Origins LED board

Quanta Computer Inc.  
PROJECT : ZHR

|       | FFC CONN /LED / HOLE   | 1A           |

## LED(UIF)

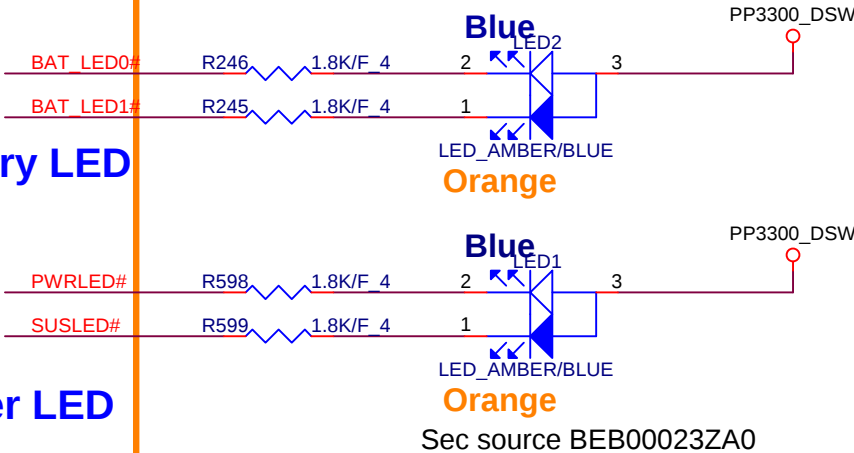
0102 Changed LED Footprint to meet ME required  
0507 Changed R246/R245/R598/R599 to 1.8K for LED luminance
